ZONING AMENDMENT,
PLANNED UNIT DEVELOPMENT &
SUBDIVISION STAFF REPORT

| <u>SUBDIVISION NAME</u> | Snowden Place Subdivision |
| <u>LOCATION</u> | North side of Cottage Hill Road, 110'+ East of Christopher Drive East. |

APPLICATION NUMBER 3, 4, & 5 DATE November 1, 2007

SITE PLAN

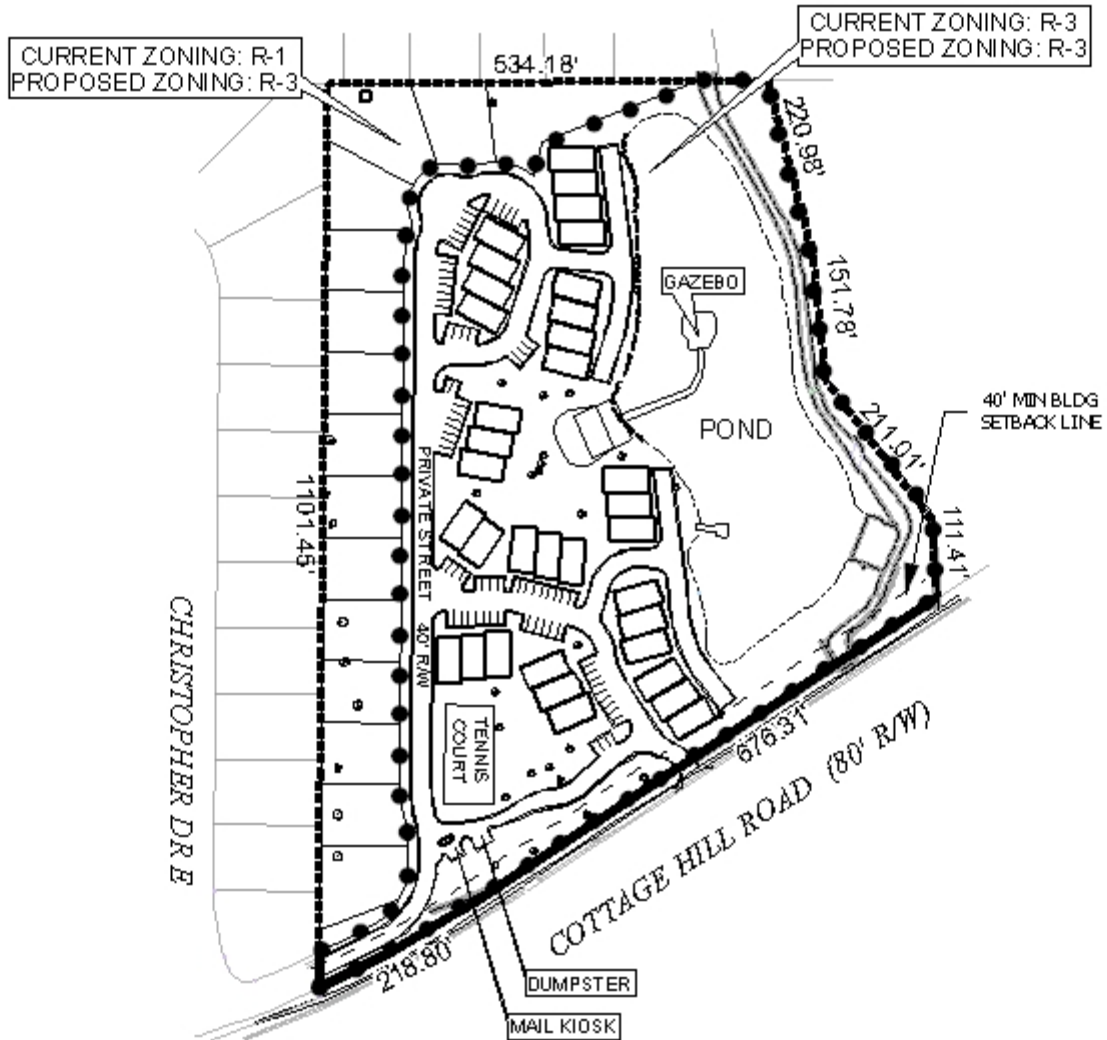
There are several issues of concern regarding the proposed development. As previously mentioned, the minimum building setback line depicted on the subdivision plat, PUD and Zoning site plans is 25-feet from the right-of-way edge of Cottage Hill Road: previous approvals required this setback to be at least 50 feet from Cottage Hill Road so that structures will not be built where a service road may be required at some point in the future. The site plan should be revised to ensure that all buildings meet the setback requirements from all adjacent street frontages, including the additional setback recommended for the service road area.

There is no information on the site plan regarding the height of the proposed condominiums, in terms of number of stories or total height in feet. It is assumed that each townhome will be at least two stories in height due to a garage being proposed for the ground floor.

While residential adjacency buffers are not required, it is recommended that a 6-foot high wooden privacy fence, at minimum, be provided where the condominium development abuts existing single-family development. The fence should be depicted on the PUD site plan.

Access management is a concern due the presence of a major street. As designed, the overall site will have one access onto Cottage Hill Road via proposed Lot 16 and one curb-cut onto the service road on the West side of the site. As previously mentioned, the Subdivision Regulations require that the private street have its own right-of-way, thus the site plan and plat should be revised.

There is no indication on the site plan as to whether the direct entrance onto Cottage Hill will be gated or not. The site plan should be revised to indicate the access status of that entrance. It should also be pointed out that the gated entrance from the service road does not provide any accommodation for turn-around prior to the gate, thus any vehicle not able to gain access to the site will be required to back-up along the service road.

The depicted dumpster pad is within the setback area being requested along Cottage Hill Road. The site plan should be revised to relocate this and the mail box kiosk to be outside of the requested 50-foot setback from Cottage Hill Road.

The site plan and plat clearly indicate the requested setbacks, however the site coverage information is not included on the plat (it is depicted on the site plan). The Subdivision plat should be revised to also indicate the requested maximum site coverage (50%) specifically for lots 1-15 in order to facilitate the staff's review of residential building permit applications in the future. It should be noted that increases in site coverage above that approved as part of the joint applications will require new PUD and Subdivision applications to amend the coverage on a lot by lot basis (if, for example, an individual home exceeds the site coverage).

Finally, the right-of-way width for Cottage Hill Road is depicted as 80 feet on the site plan and plat. It is believed that the right-of-way at this location is at least 100 feet in width, thus the label on the site plan and plat should be revised, or additional right-of-way should be dedicated to provide 50-feet, as measured from the centerline of Cottage Hill Road.

A revised site plan, plat and legal description were provided by the applicant. The revised site plan depicts a gated private street with a 40-foot wide right-of-way, and with at least a 10-foot minimum building setback along the private street. A 40-foot minimum building setback has been provided where the site abuts Cottage Hill Road, and all proposed structures have been located to be outside of the 40-foot setback.

The site plan indicates that the access point to Cottage Hill Road will be for emergency access only, and will not be available for normal access. The existing wall along Cottage Hill Road will also be retained. A note on the site plan states that the site plan has been reviewed and approved by the City of Mobile Fire Marshal.

The site plan also has notes indicating that the existing pond is adequate for storm water detention requirements, and that there are no wetlands on the site.

- 7) Revision of the site plan to label the correct width of the right-of-way for Cottage Hill Road, or dedication of right-of-way necessary to provide 50-feet, as measured from the centerline of Cottage Hill Road;*

DETAIL SITE PLAN

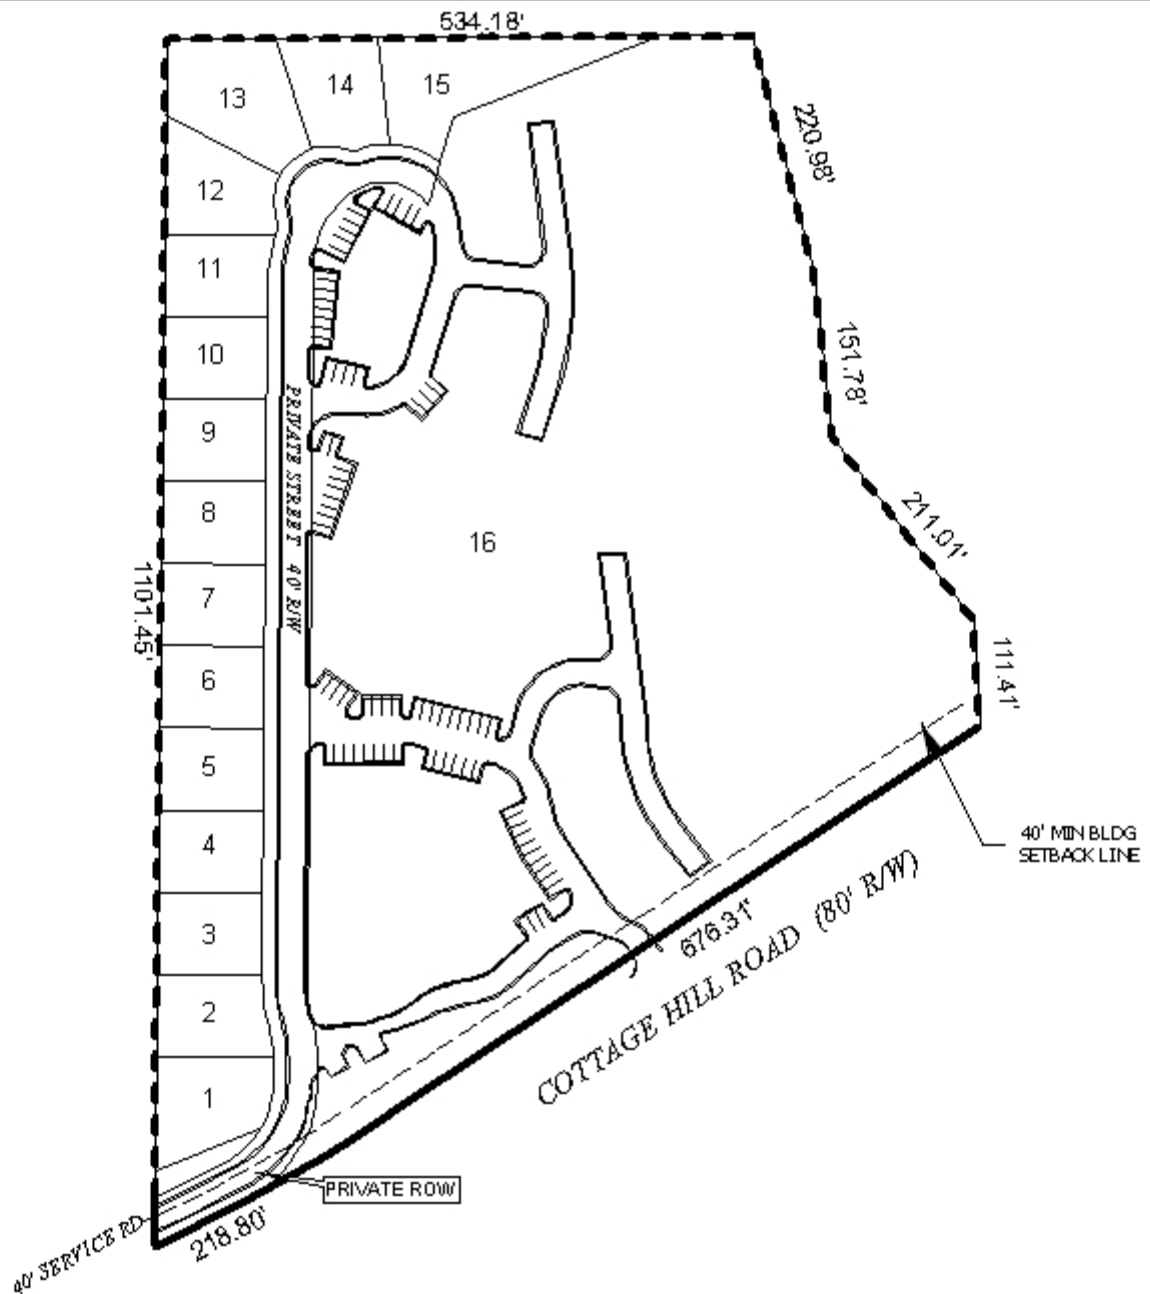
Due to the limited width of the proposed private street, access management is a concern. Lots 1-15 should be limited to one curb-cut each, and lot 16 should be limited to the curb-cuts as depicted on the PUD site plan. The size, design and location of all curb-cuts are to be approved by Traffic Engineering and comply with AASHTO standards.
